JUNEAU INTERNATIONAL AIRPORT TAXIWAY A REHABILITATION, TAXIWAY D-1 RELOCATION & TAXIWAY E REALIGNMENT

Contract No. BE19-218

ADDENDUM NO.: TWO

August 16, 2019

DATE: 06/12/19
SHEET: E541 OF 233
AS-BUILT SHEET:

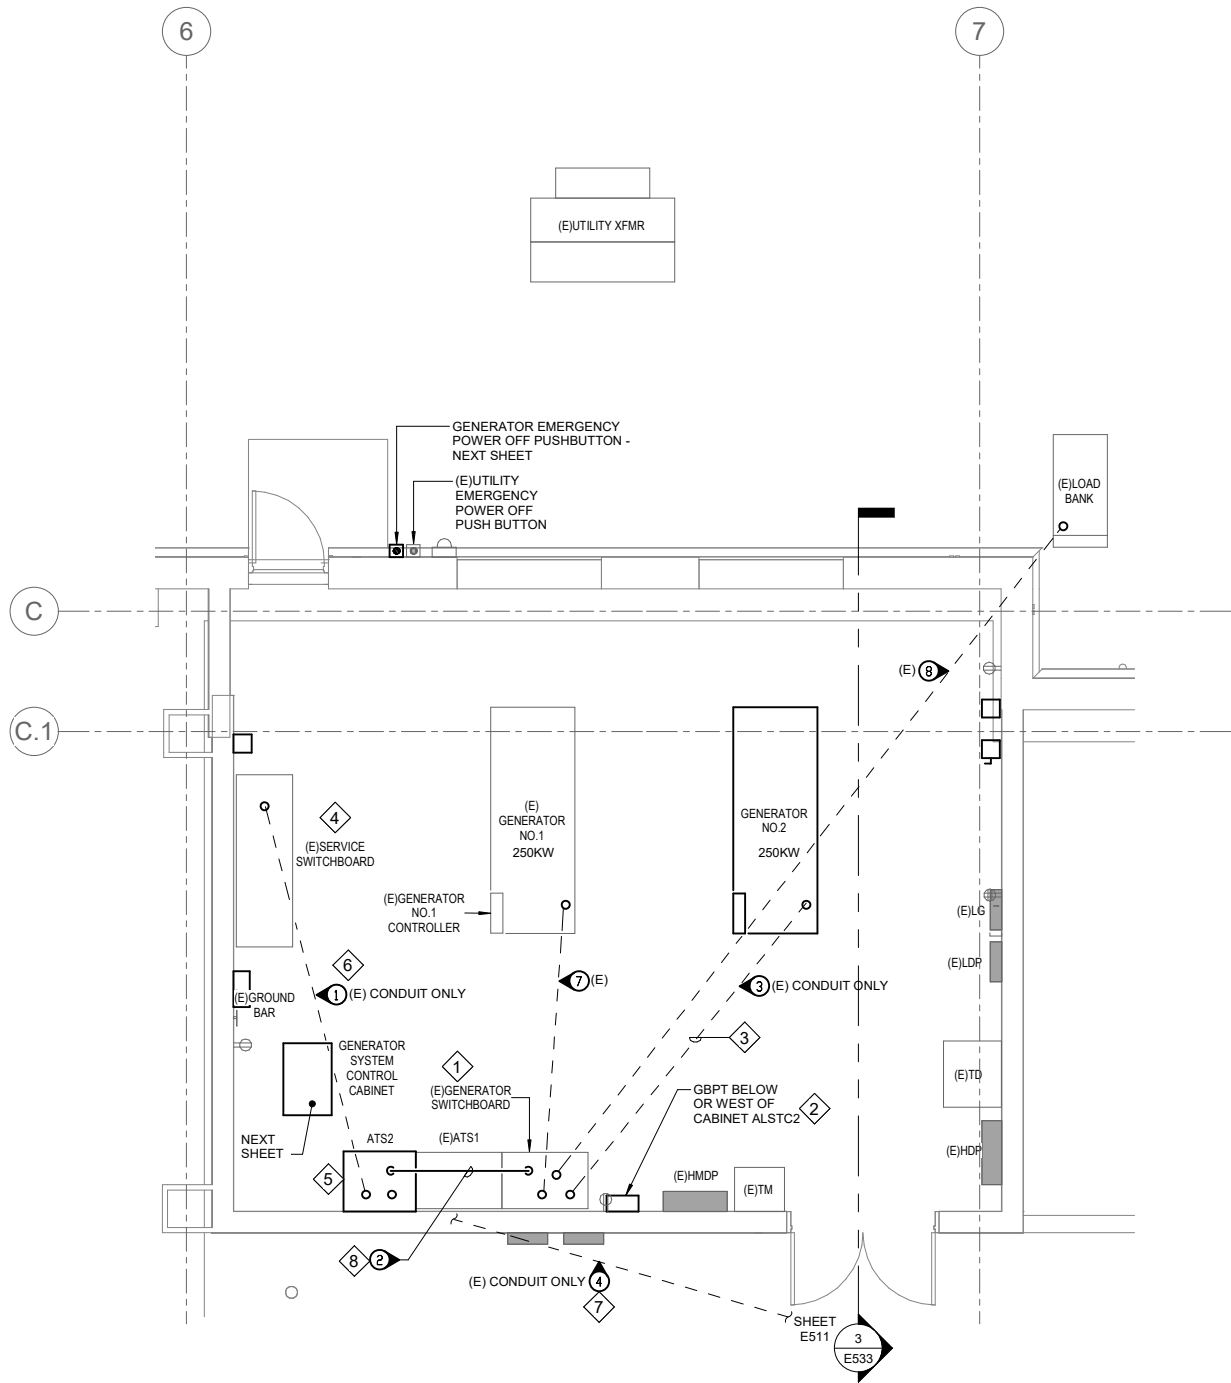
Question 8. *"Spec 26 32 13 item 2.09.A.1.a and 2.09.C - What is the expected / required communication interface between GCSC the Load Bank Controller as listed in? Can a proposed sequence of operations be provided for our review? It seems that the Load Bank Controller would be installed in the same room as the GCSC (as depicted on dwg E542)."*

Yes, the Load Bank Controller would be installed in the same room as the GCSC (as depicted on dwg E542).

DATE: 06/12/19
SHEET: E544 OF 233
AS-BUILT SHEET:

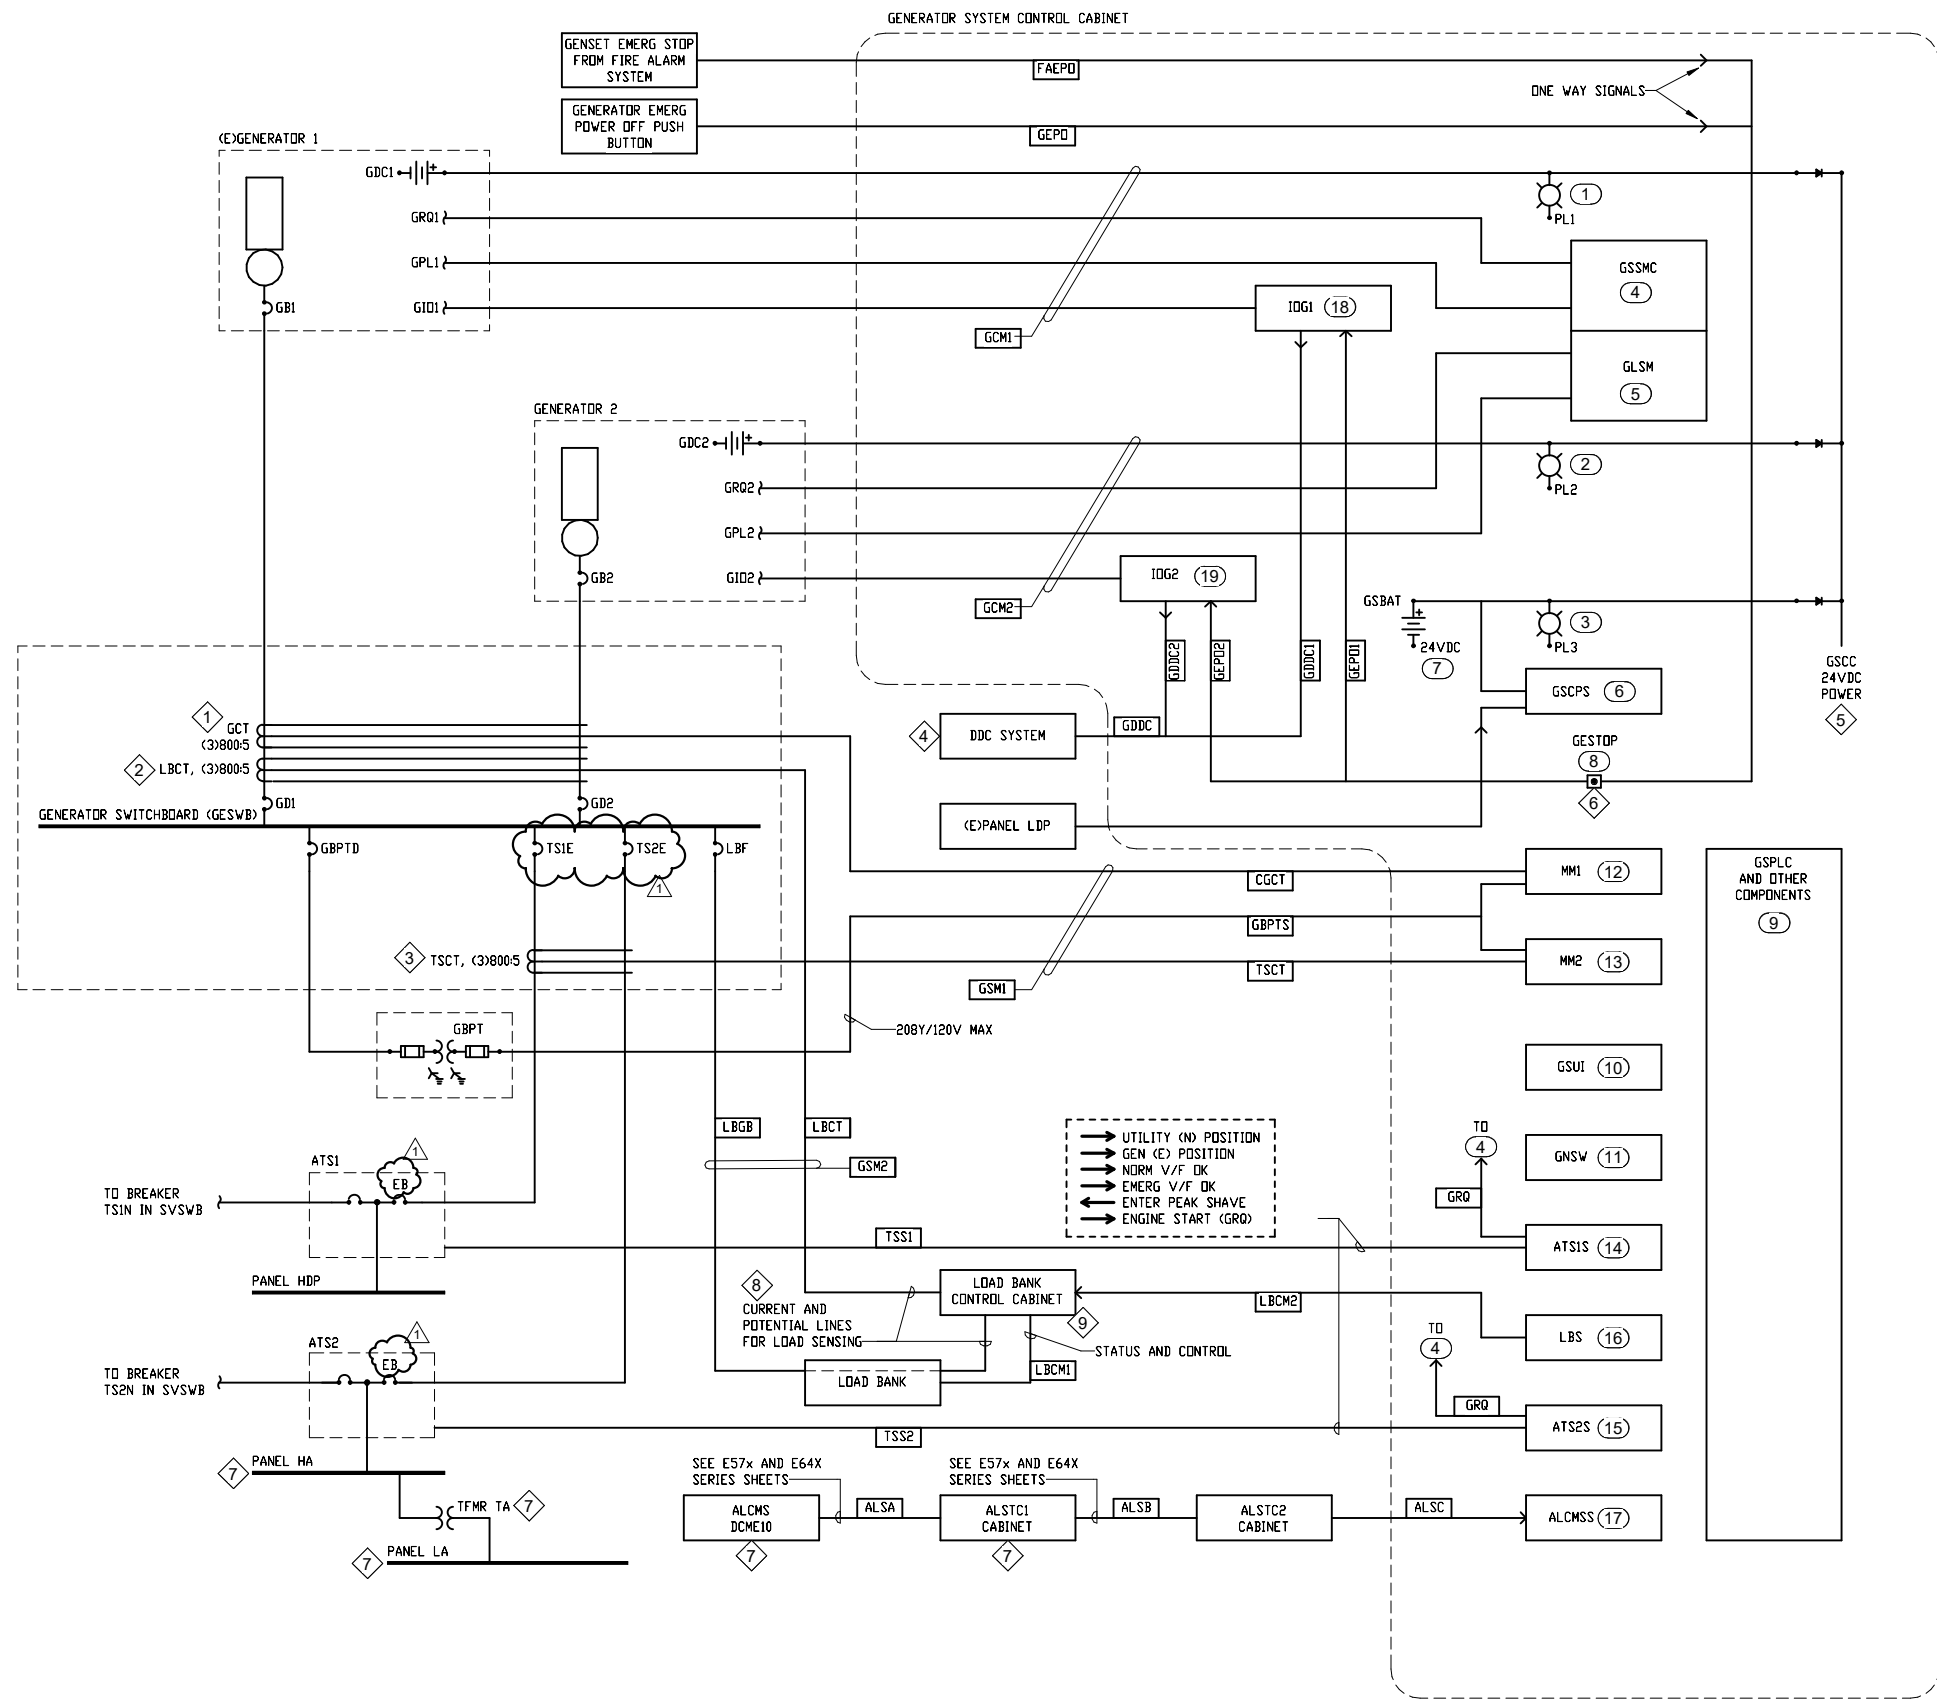
Question 12. *"Dwg E544 - GCSC to interface with DDC I/O for HVAC operation in Gen Run Mode. More detailed clarification is needed for such interface?"*

Question 13. *"Dwg E544 - FYI, both Gens to be controlled by GCSC which has a Gen Load Sense / Demand feature. It is recommended that Load Bank operation be utilized when only during 1 gen operation. Additional clarification is required for Gens & Load Bank integrated intended theory of operation."*

Question 14. *"Dwg E544 - Based on the CTs circuits shown on this page, it seems that MM1 power quality meter is for metering both G1 & G2; and that MM2 power quality meter is for metering both ATS1&2 loads. Please confirm if all of these additional expensive meters are indeed required."*

Question 17. *"Dwg E544 - GCSC to be provided with independent control 24VDC battery (keynotes #4)"*

Question 18. *"Dwg E544 - GCSC to be provided with various interface with Load Bank Controller & to monitor both ATS1&2 status. GCSC must be capable to provide a Load Dump signal to Load Bank Controller but keep the Load Bank circuit breaker normally closed."*

Response: From GSCC perspective what is required is a dry contact that signals DDC that the respective engine is running (the existing SREB DDC and Mechanical system revision work is defined under Mechanical).

Response: Load Bank is required to be utilized with either or both generators operating.

Load Bank is utilized with either or both generators (see also item Drawing E543 Markup); also if the generator provided under this project is fully compatible with the existing generator (meaning they are both Caterpillar units that can be directly networked for load sense/demand functionality), the GSCC is not required to provide those elements (but the network cable must pass through the GSCC).

If the generator provided under this project is fully compatible with the existing generator (for example both generators are Caterpillar units that can be directly networked for indicated functionality), the GSCC is not required to include separate controlling elements (but the network cable between the generators must pass through the GSCC).

Response: The CT windows enclose phase conductors of multiple feeders as indicated. The arrangement is centric to ATS2 being a "Molded Case Switch" type.
See Addendum #2.

Response: Battery GSBAT and related charger GSCPS represent a separate 24VDC power source in addition to the generator engine 24VDC supplies.

Response: Yes, defined further on sheets E543 - E546 and E552.

DATE: 06/12/19
SHEET: E552 OF 233
AS-BUILT SHEET:

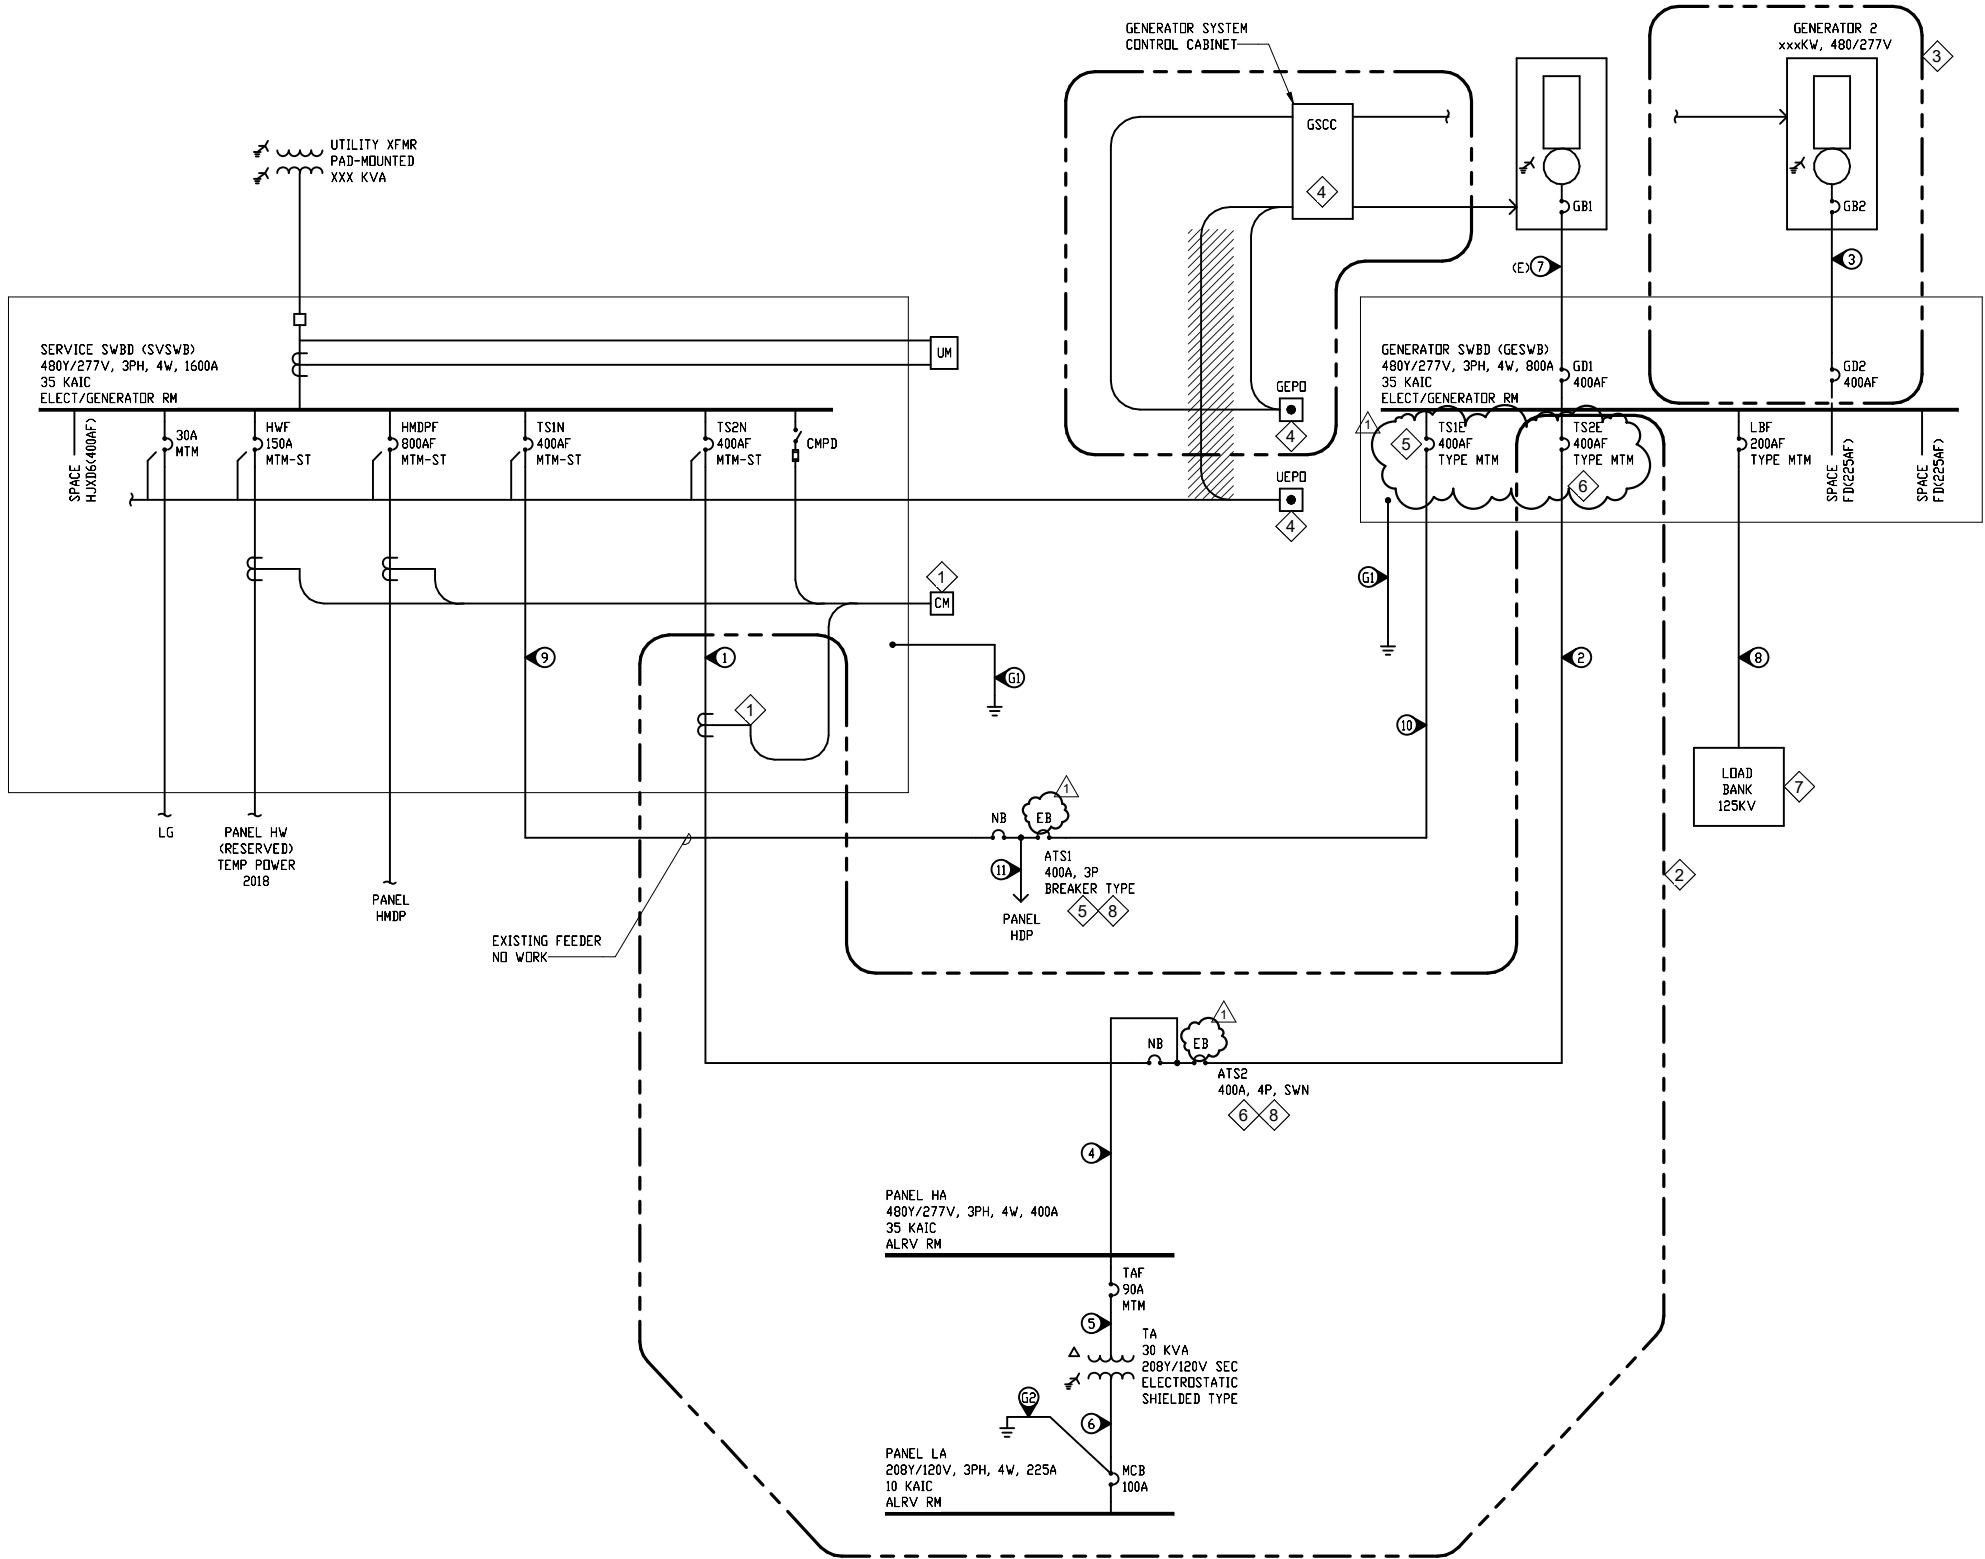
Question 5. *"Spec 26 36 00 Item 2.2 - It calls for Contactor type ATS; however dwg E552 keynotes #6 seems to indicate a preference for ATS2 to match the existing ATS1 being a breaker type. Existing ATS1 has a molded case switches with short circuit protection not overcurrent. Will overcurrent upgrades need to be incorporated into ATS1 as well as new ATS2?"*

Question 16. *"Dwg E542 - Must be capable of receiving remote EPO shutdown signal (keynotes #4)"*

Response: See Addendum #2

Response: Yes, defined further on sheets E543 - E546 and E552. See Addendum #2

DATE: 06/12/19
SHEET: E554 OF 233
AS-BUILT SHEET:

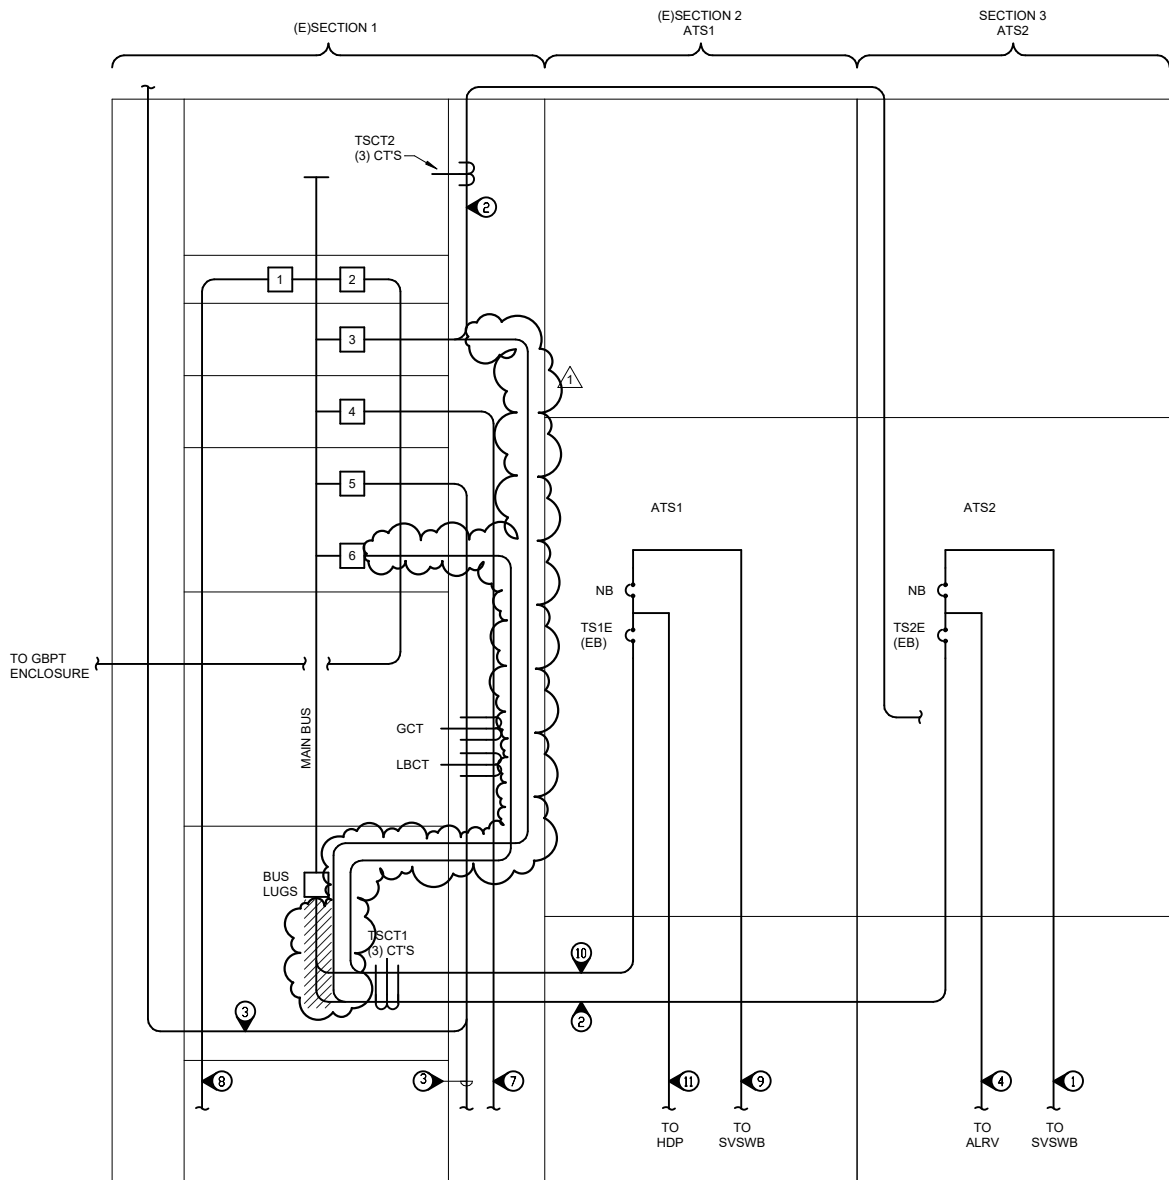
Question 15. *"Dwg E554 - Who is responsible to provide these additional CTs into the existing Gen Swbd?"*

Response: Provision of the current transformers (CT's) is to be coordinated by the Contractor and presumably the GSCC builder/integrator (subcontractor to generator supplier?). The CT's to be provided are first defined through interpretation of the Schedule Notes in concert with the type of ATS2 selected (so for Molded Case Switch Type ATS2 the Schedule Note 3 tells what CT's apply). CT accuracy requirements are to be coordinated with the Load Bank and GSCC metering; design intent is the more stringent requirement applies to all CT's; otherwise, the usual non-revenue operational metering (based on ANSI Type switchboard meters) for generator paralleling switchboard application applies.
